Harrisville City Planning Commission

Wednesday, July 13, 2022 – 7:00 p.m.

RE: **DIXON CREEK PARK PHASES 1-5 SUBDIVISION**
Preliminary Plat Submittal

Date: July 7, 2022

C610
SEWER PLAN

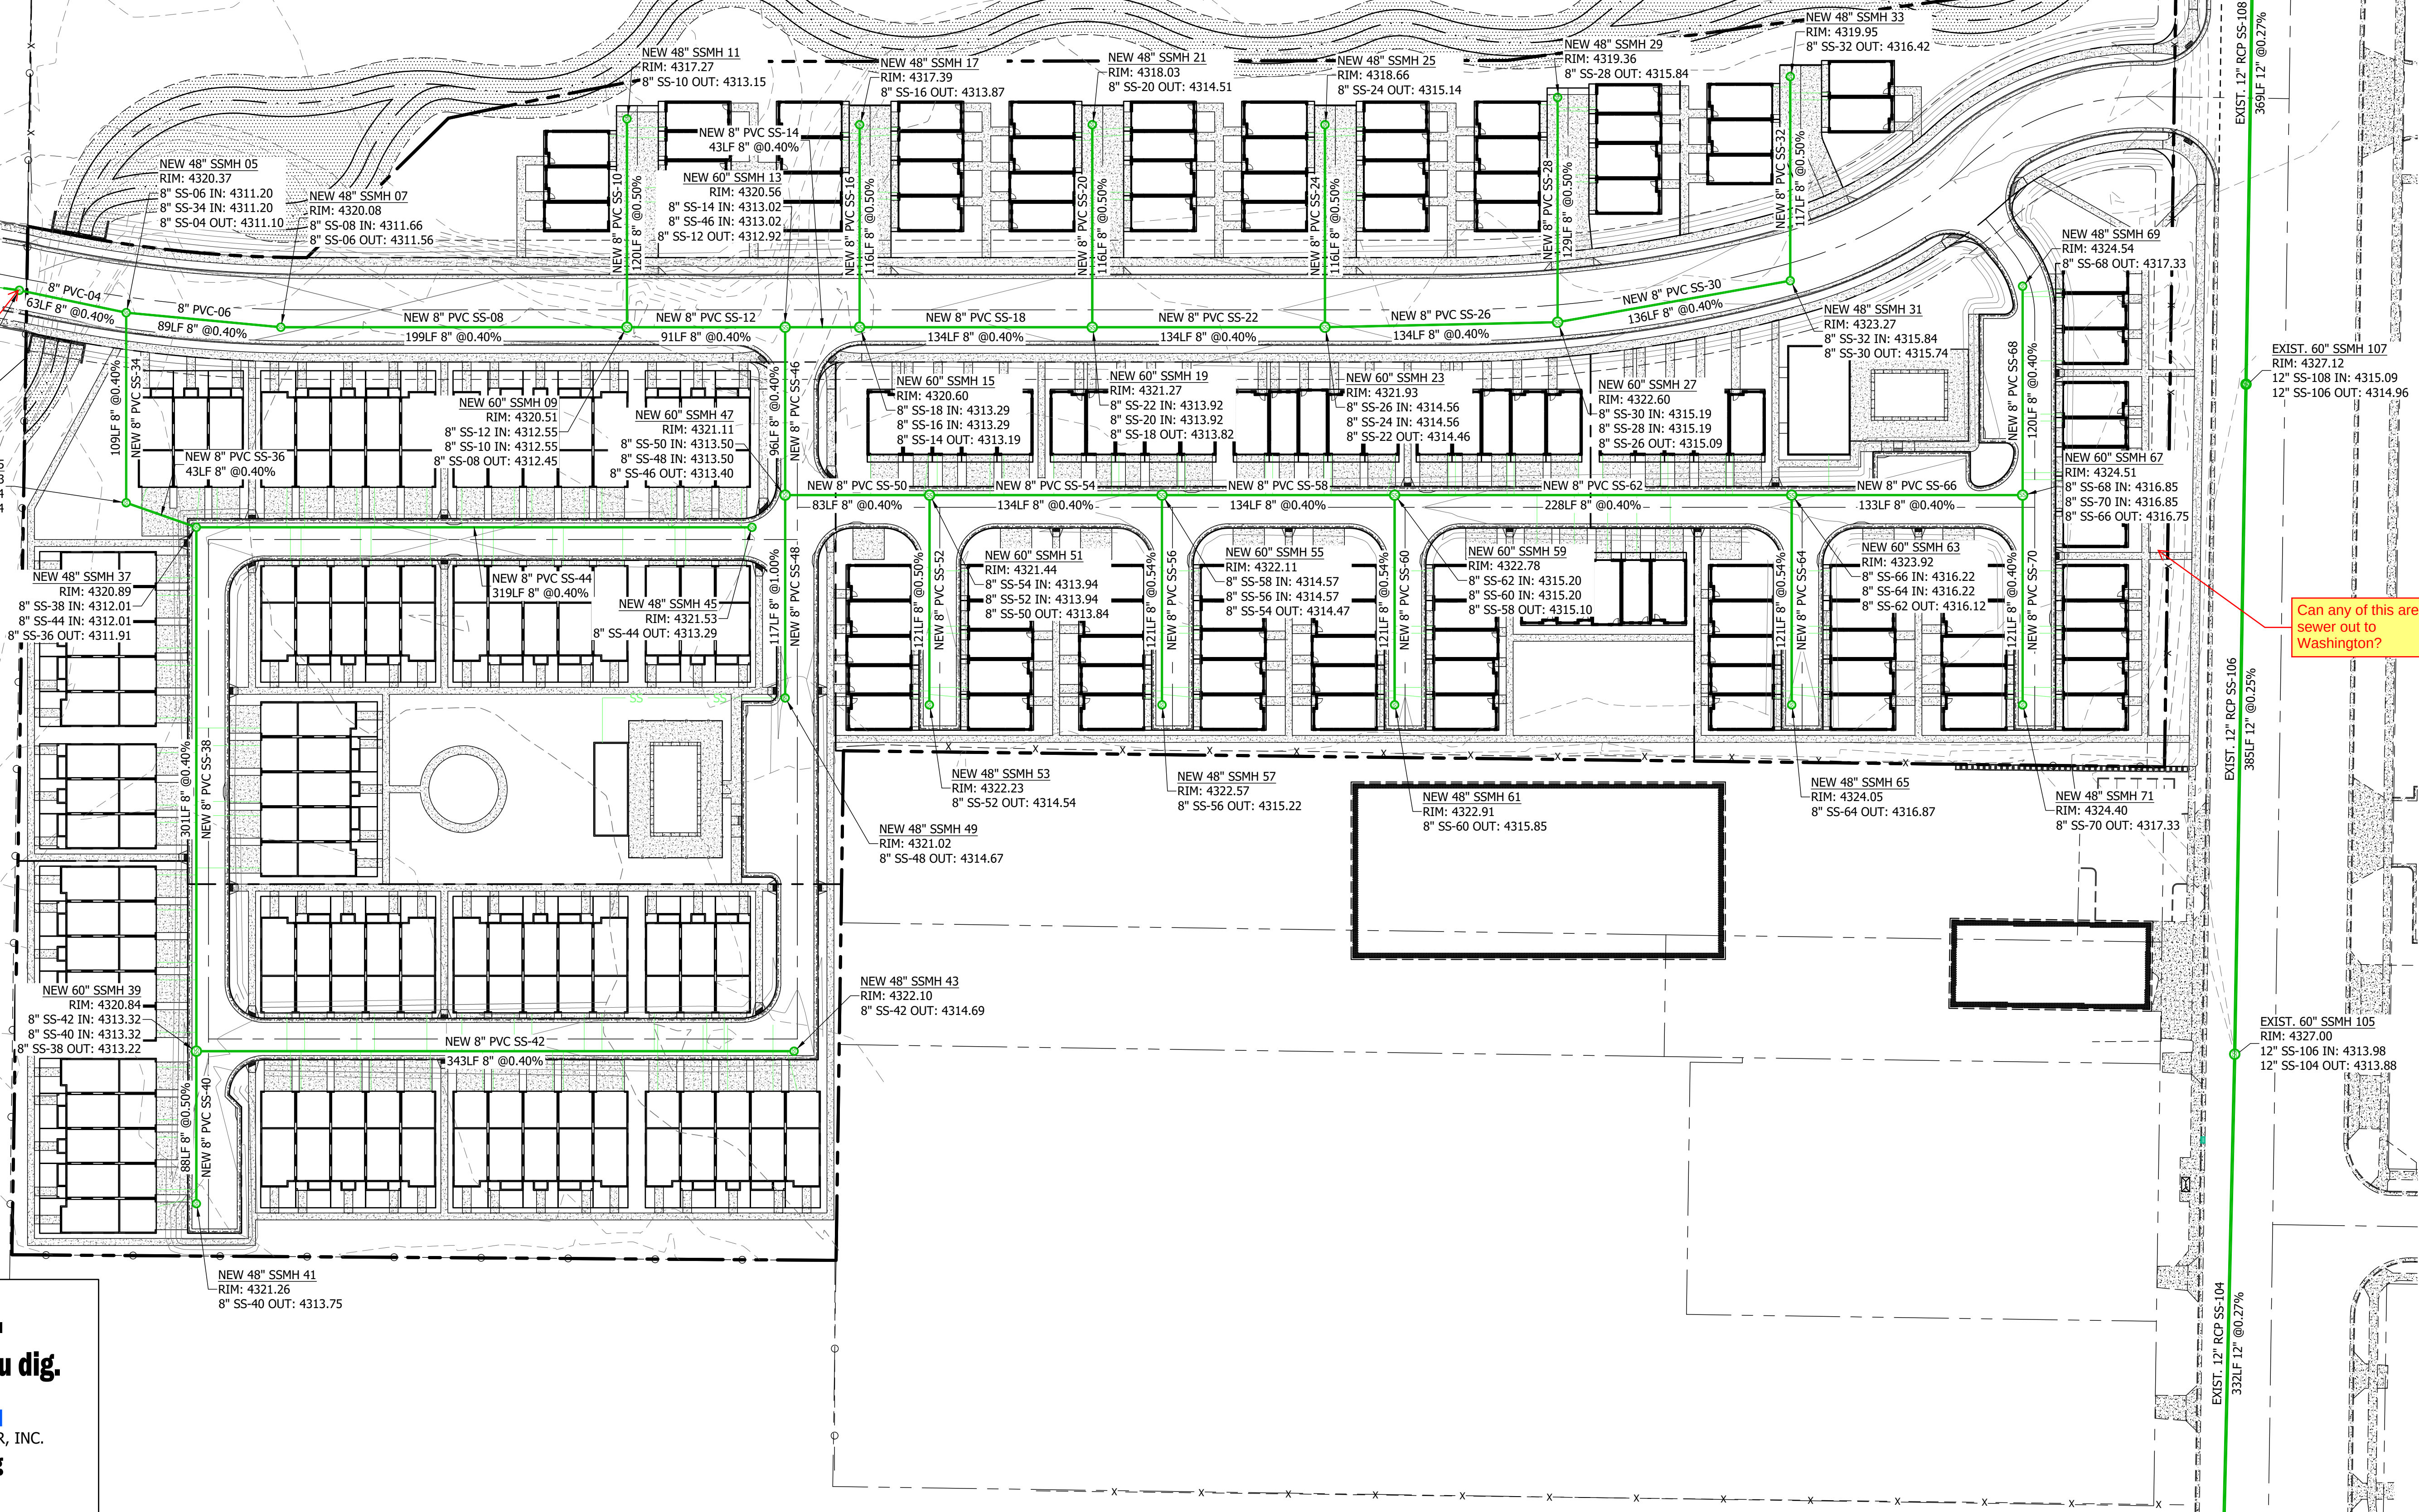
Existing system will be over capacity with all of the units connected. See if any units can sewer out to the line in Washington Blvd.

Can any of this area sewer out to Washington?

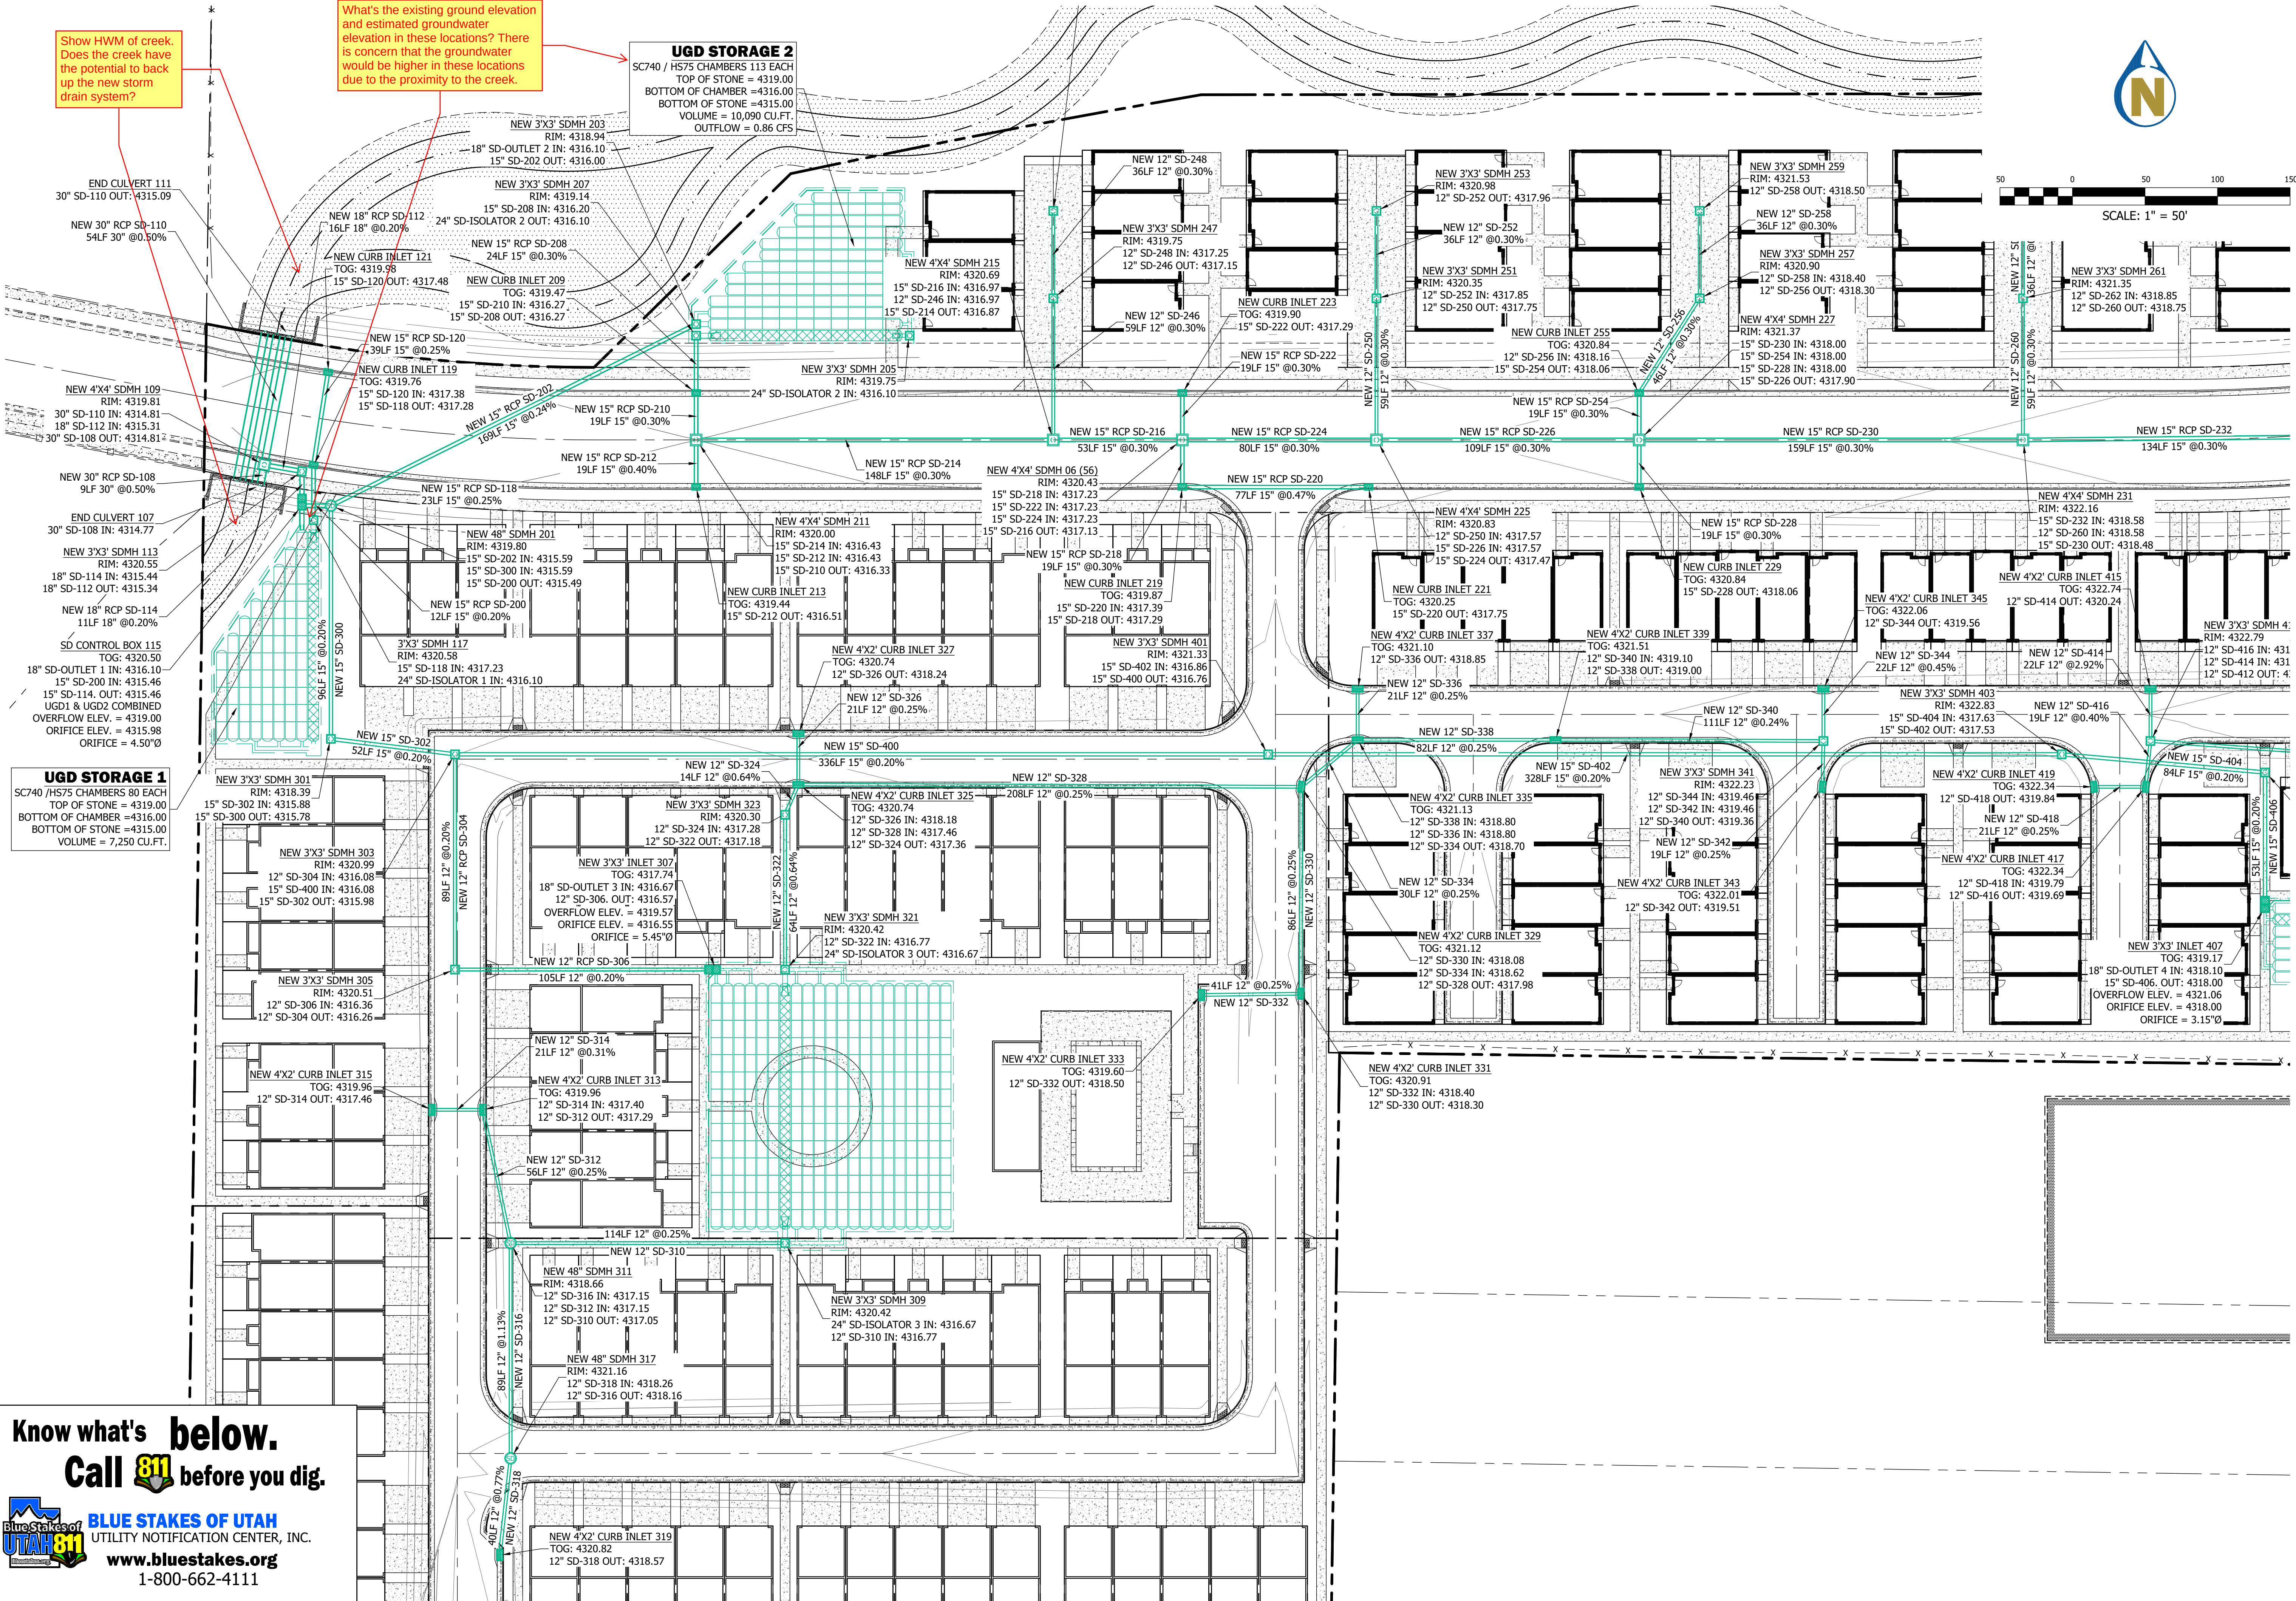
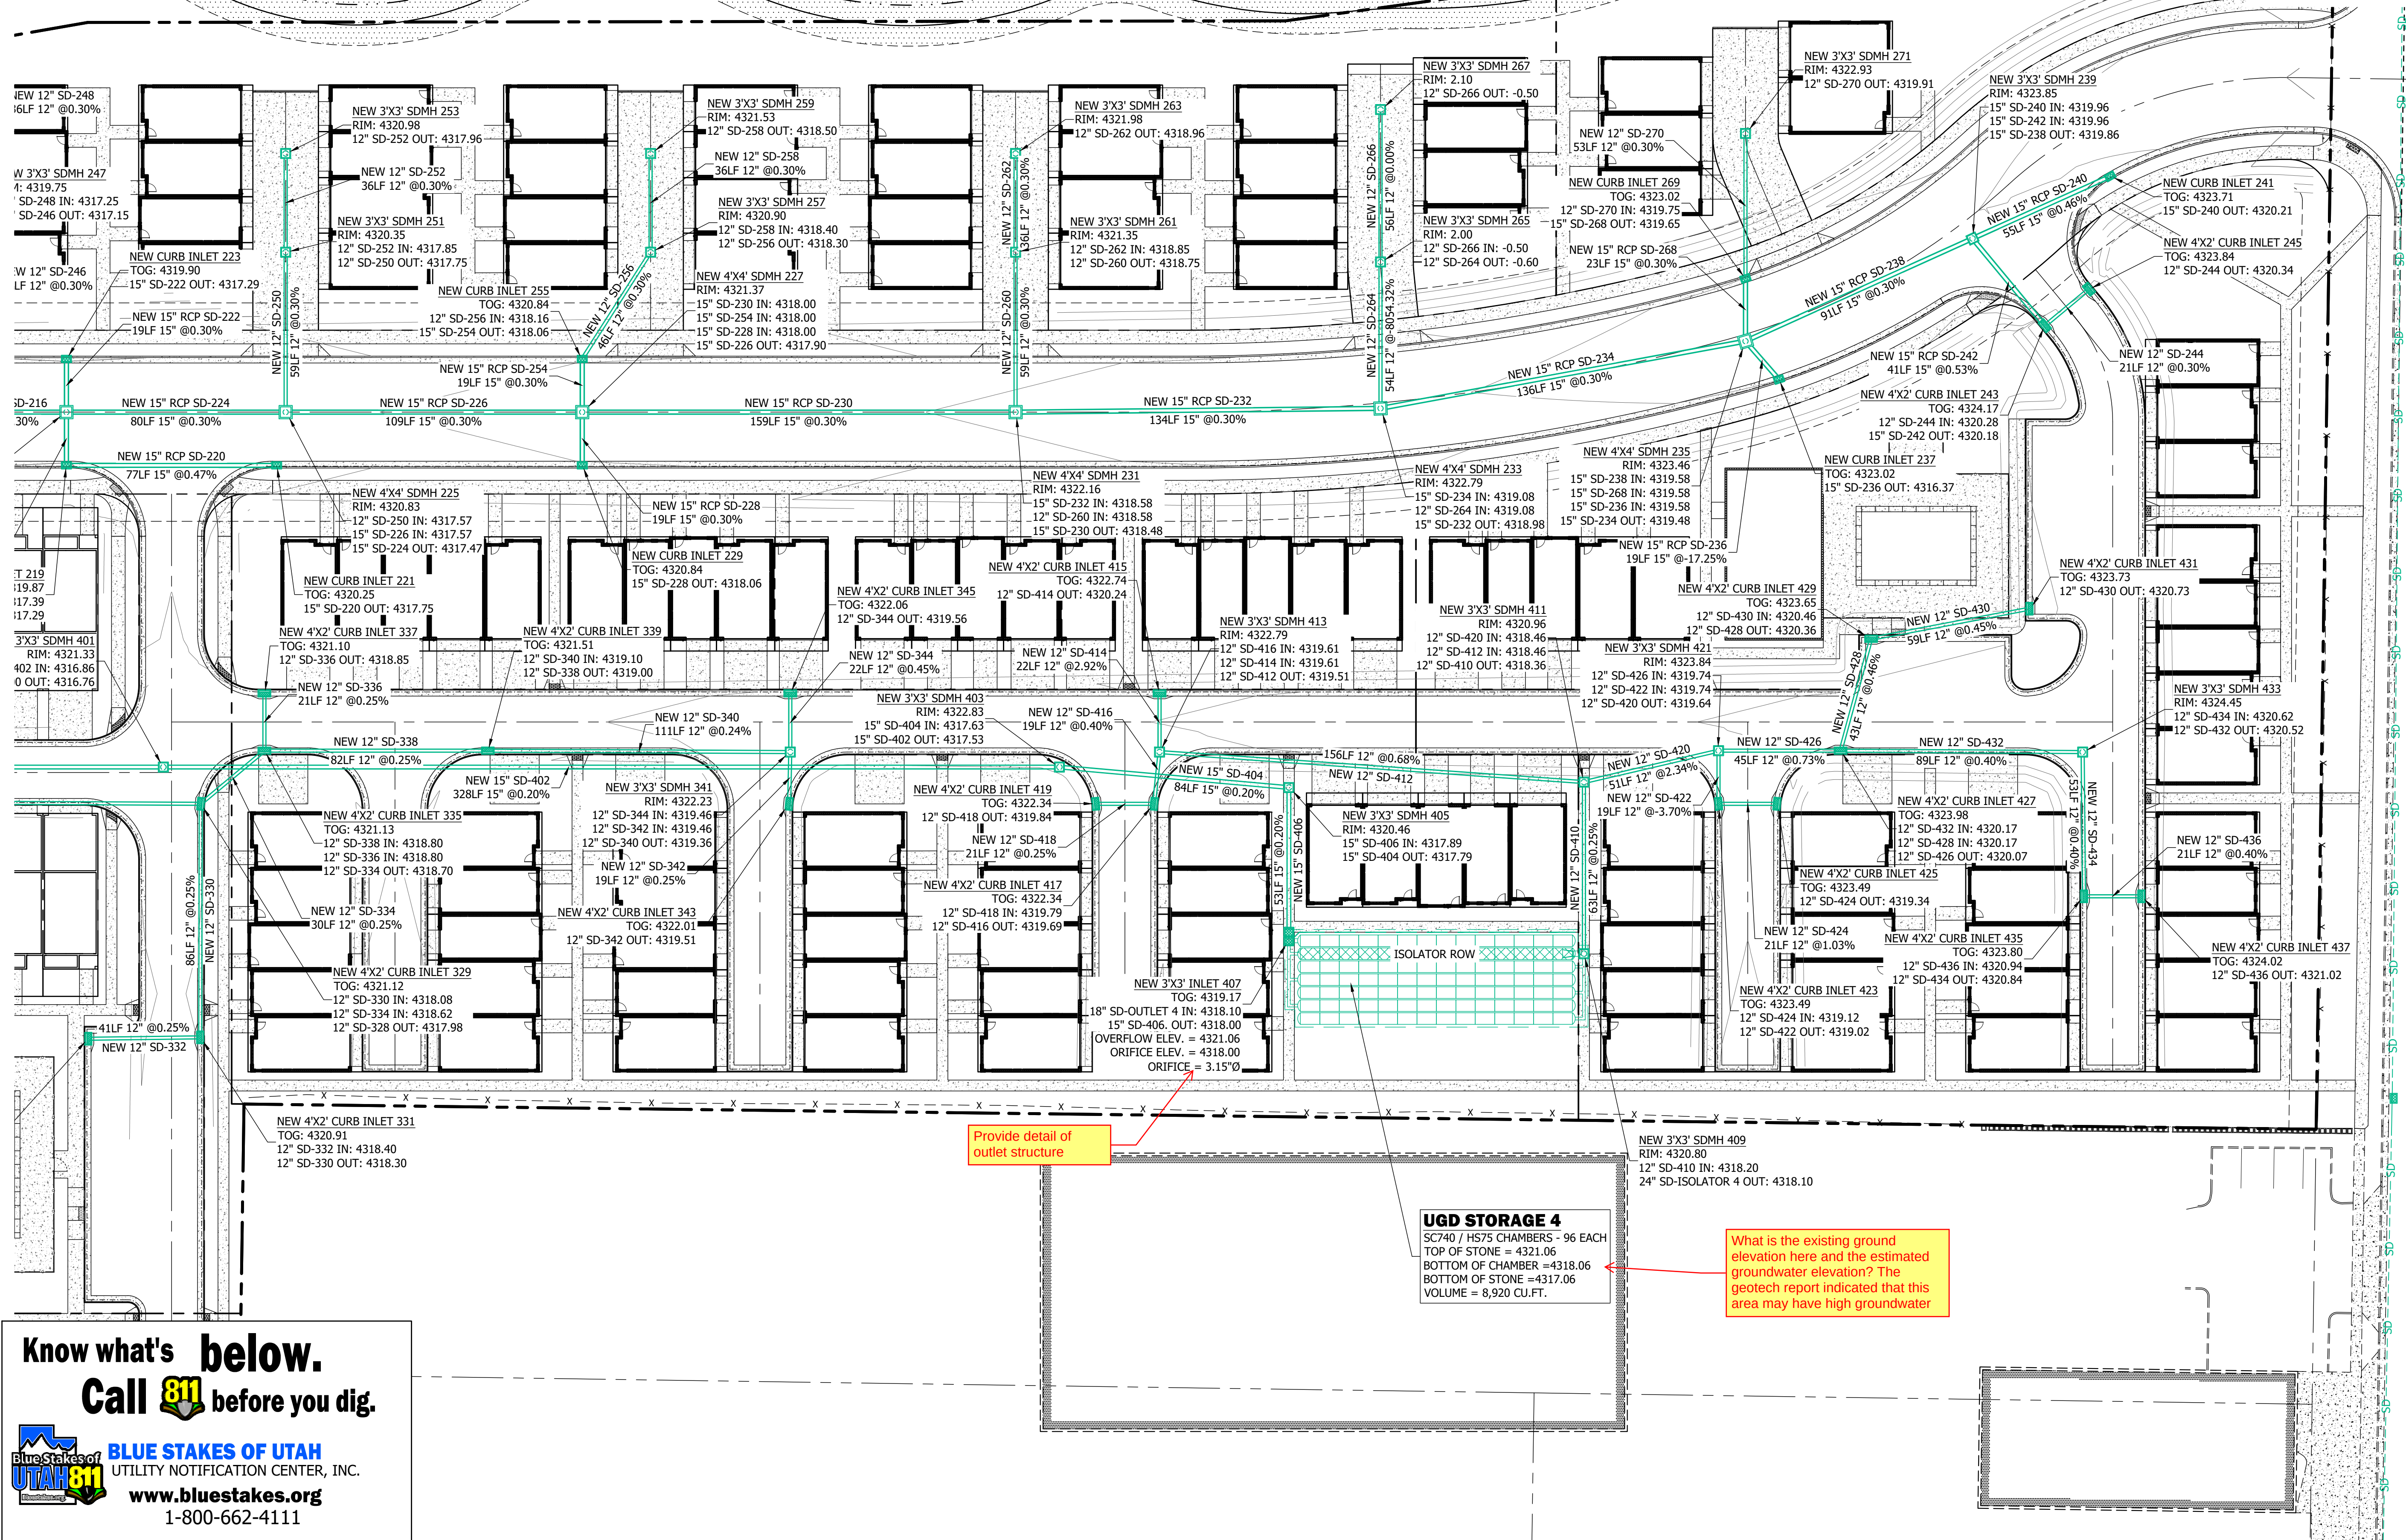
Show HWM of creek.
Does the creek have
the potential to back
up the new storm
drain system?

What's the existing ground elevation
and estimated groundwater
elevation in these locations? There
is concern that the groundwater
would be higher in these locations
due to the proximity to the creek.
